***ALTERNATIVES CONSIDERED  
BUT REJECTED***

***Appendix H***

Date: October 24, 2001  
To: Pat Baughman, Pierce County Public Works  
From: David Mattern *DM (by SR)*  
Subject: Preliminary environmental review of Tahoma Audubon's new alignment  
cc: John Perlic, File  
Project Number: 554-1588-030  
Project Name: Cross-Base Highway EIS

Date: February 5, 2002  
To: Pat Baughman, Pierce County Public Works Department  
From: Theresa Turpin, Parametrix/Sumner  
Subject: Cross-Base Windshield Survey – Spanaway Loop Road  
cc: Jenny Bailey, John Perlic, Project File  
Project Number: 554-1588-030  
Project Name: Cross-Base Highway Supplemental DEIS

**Cross Base Windshield Survey  
Cross Base Highway Project**

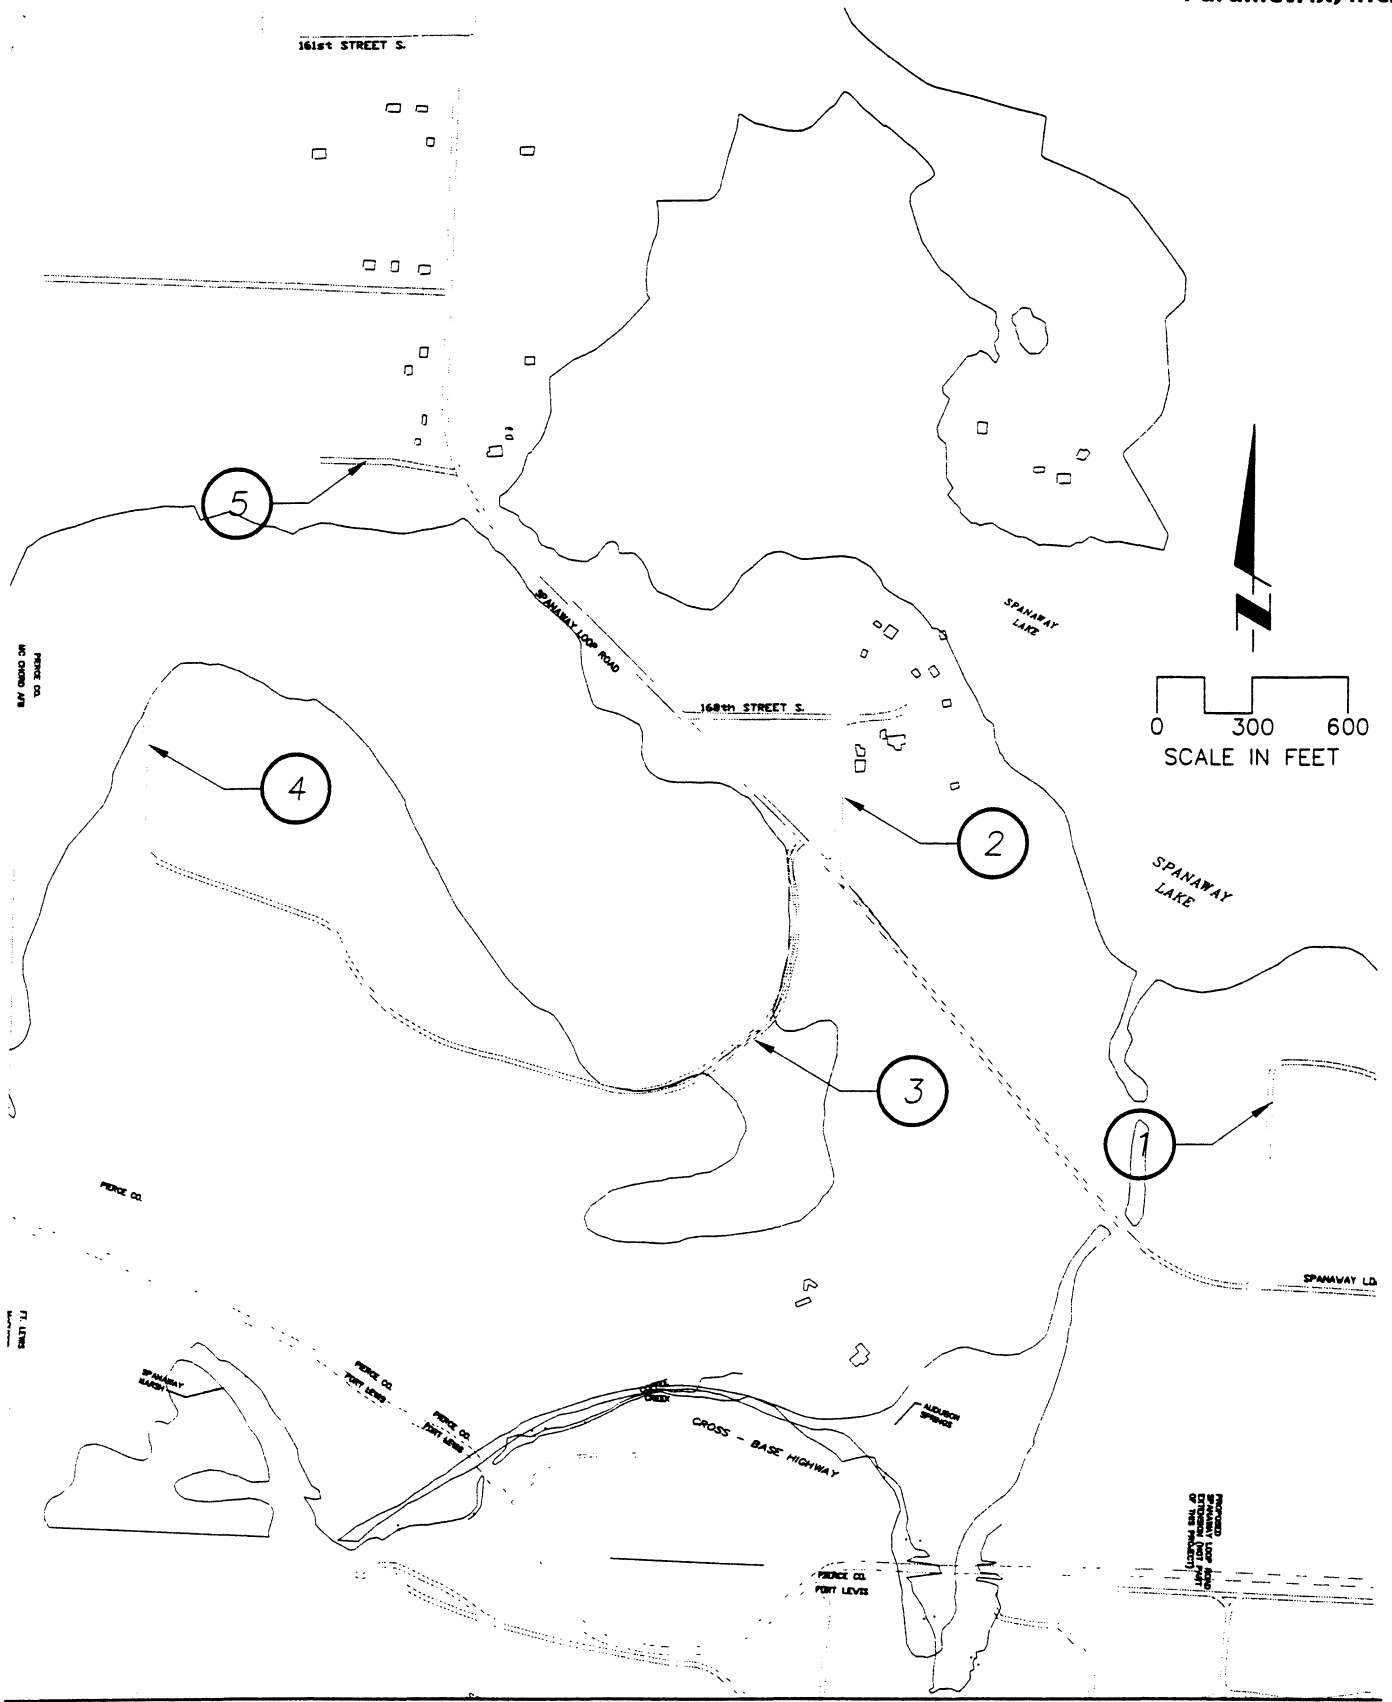
On Friday, January 11, 2002, a “windshield survey” of Spanaway Loop Road was conducted in the area from 166th Street South to 10th Avenue South, encompassing both sides of Spanaway Loop Road and side roads. The purpose of the survey was to identify the number of residences potentially affected by the Cross-Base Highway alignment suggested by Tahoma Audubon. The area is a mixture of residences, including single family dwellings, mobile homes, apartments (on 10th Avenue South), and condominiums (see attached map).

Due to the limited access design and function of the proposed Cross-Base Highway, access to some or all of the residences on the east and west sides of Spanaway Loop Road may not be possible. Without access, up to 239 residences could be displaced as a result of the alignment suggested by Tahoma Audubon. The attached map shows the location of residences potentially displaced by Tahoma Audubon's proposed alignment.
